CNRO-2005-00014

SUBJECT: Request for Alternatives W3-R&R-003
Response to NRC Request for Additional Information

Waterford Steam Electric Station, Unit 3
Docket No. 50-382
License No. NPF-38

**RESPONSES TO NRC's REQUEST FOR ADDITIONAL INFORMATION
SUPPORTING REQUEST FOR ALTERNATIVE W3-R&R-003**

Figure 4
Pressurizer Upper Head Instrument Nozzle Repair

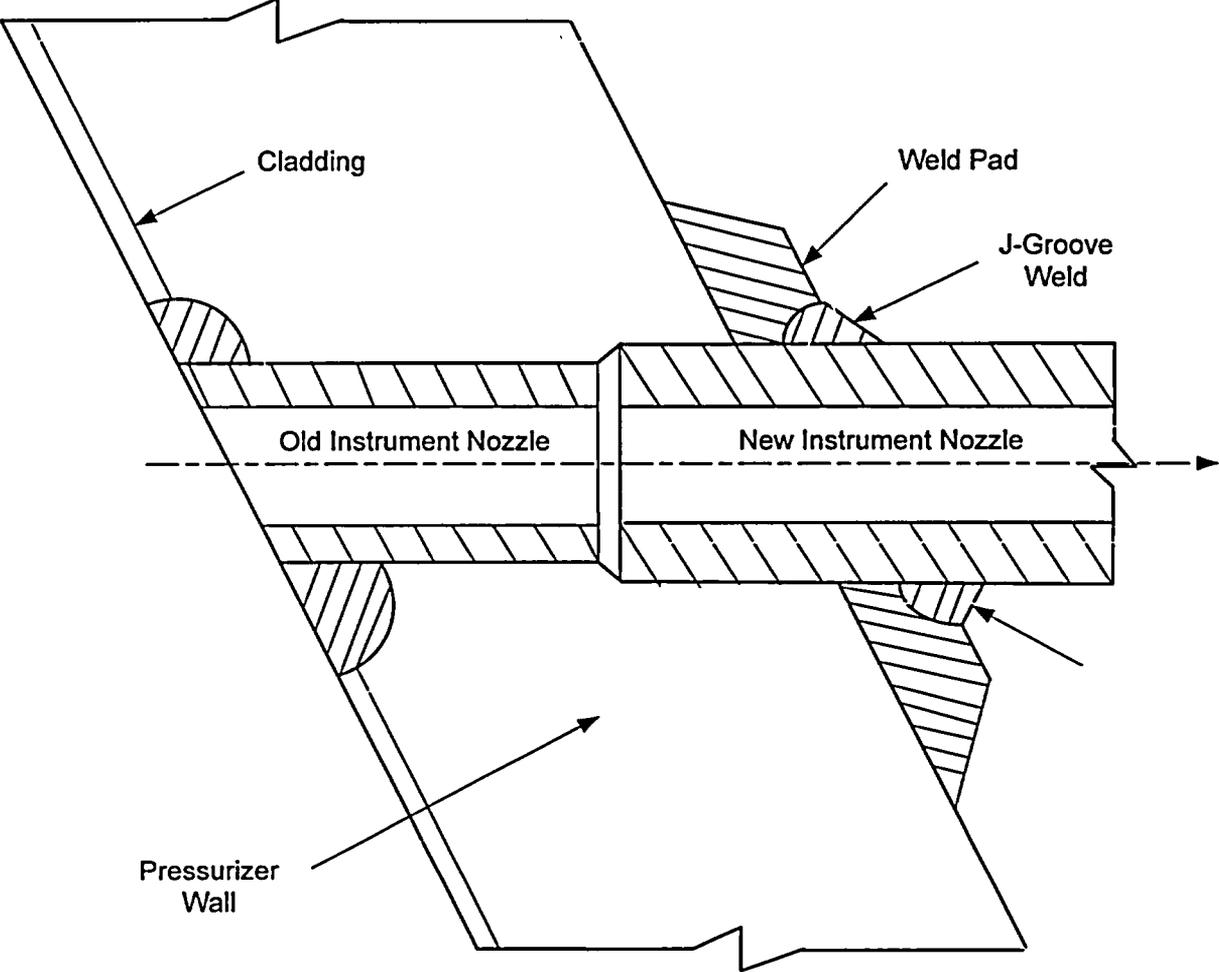
1. On page 3 of the Request under, "OD Weld Pad Repair of Previously Repaired Upper Head Instrument Nozzles," Entergy states that the existing nozzles and associated attachment welds will be removed by grinding. How will the licensee ensure that all of the 182 filler metal will be moved to minimize the potential for future primary stress corrosion cracking (PWSCC)?

Entergy's Response: *The design dimensions of the outside diameter weld pads, J-welds, and instruments nozzles are clearly documented in WF3 design drawings. Entergy has also located the original work package documentation for these welds. However, while the work package documentation seems to suggest that the J-weld preparations were made by grinding as opposed to machining, this cannot be confirmed. Therefore, to account for a J-weld that is potentially larger than the minimum required by design, Entergy plans to perform the following:*

- ***Mock-up Testing:*** *Prior to performing this repair, a full scale mock-up will be prepared based on design drawings to establish the capability of repair personnel to remove the existing 082 weld metal using hand grinding techniques. Depth gauges will be fabricated and used to assist in the excavation activities during the mock-up.*

- ***Repair Excavation:*** *The excavation activity to remove the 082 weld metal will be performed in several steps. First, the J-weld will be excavated to the original design dimensions in both depth and radial directions. Depth gauges will be used to assist in the excavation activities. If the nozzle is still attached by weld metal at the design depth, then this would indicate that the original weld preparation is deeper than the minimum depth required by design. Grinding in the depth direction of the weld root area will continue until the nozzle becomes free. Once the nozzle becomes free, the bottom of the J-weld preparation (in the weld root area) has been reached. To provide assurance that all 082 weld metal (and 052/082 weld dilution zone) has been removed, an additional 1/16" of weld metal will be ground from the excavation. At this point, Entergy believes that all 082 weld metal will be removed from the weld root area. Based on this final excavation depth in the weld root area, Entergy will perform additional grinding outside the weld root area in the radial direction with the intent of removing all 082 weld metal along the face of the J-weld preparation. Upon completion of all excavation activities, a PT of the repair cavity will be performed.*

In conclusion, Entergy is confident that it can remove all 082 weld metal from the weld root area along the bottom of the original J-weld preparation. However, Entergy cannot be absolutely certain that all 082 weld metal will be removed from the weld area along the face of the J-weld preparation which is outside of the weld root area since Entergy has been unable to locate any conclusive "as-built" dimensions. Although this is the case, this

will not cause future PWSCC cracking for the following reasons: (1) All 082 weld metal will be removed from the weld root area and replaced with 052/052 Modified weld metal which is resistant to PWSCC. The J-weld root area is the only portion of the J-weld that will be exposed to primary water. (2) Although there is a potential that some 082 weld metal may be left from the original weld along the J-weld face, this weld metal is located away from the weld root and will be isolated from primary water by resistant 052 weld metal. Therefore, it would not be subject to PWSCC.
